Docket Item # 2
BAR CASE # 2012-0416

BAR Meeting
January 23, 2013

ISSUE: Revisions to Previously Approved Plans
APPLICANT: Jorge & Lorie Nevares by Carter Jones, AIA
LOCATION: 114 North Patrick Street
ZONE: CD / Commercial

New Roof Plan
24 December 2012
3/16" = 1'-0"

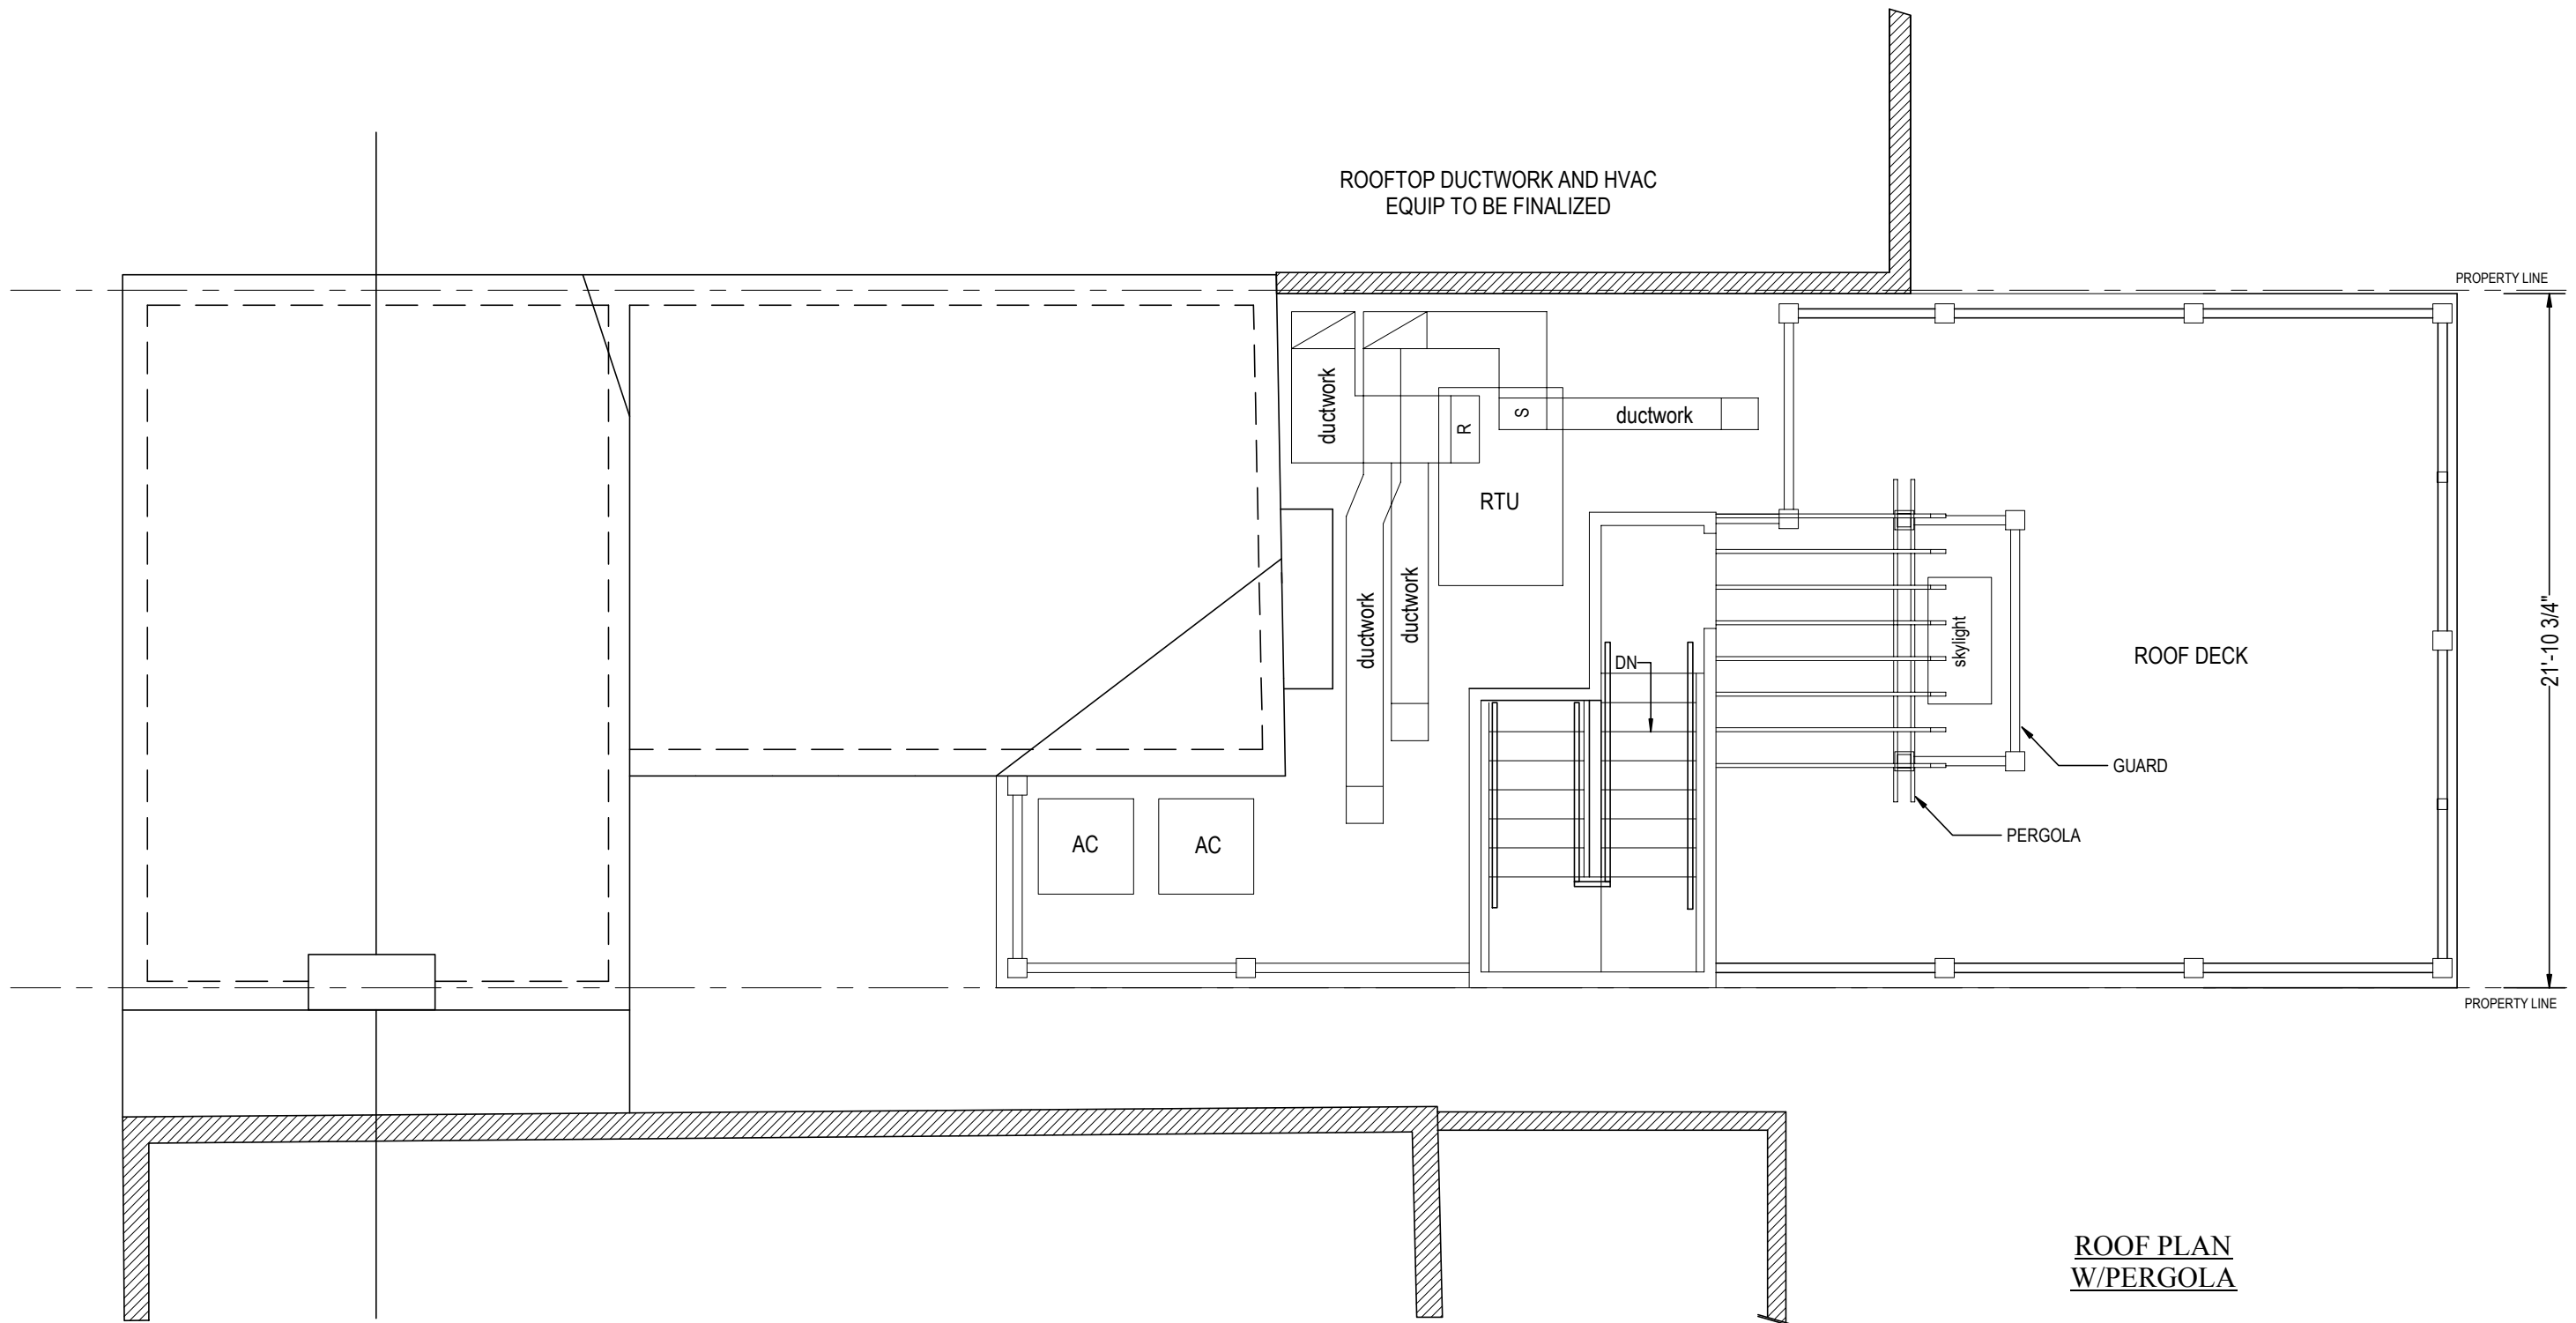
Staff recommends approval of the application with the condition that the materials used for the roof deck must be high-quality materials consistent with the Board's adopted policies and what the Board previously approved for the addition.

Although not specified on the plans, it is understood that the proposed materials for the roof deck stair access and pergola must match the materials approved for the addition which include smooth fiber cement siding and trim and a painted Trex composite railing.
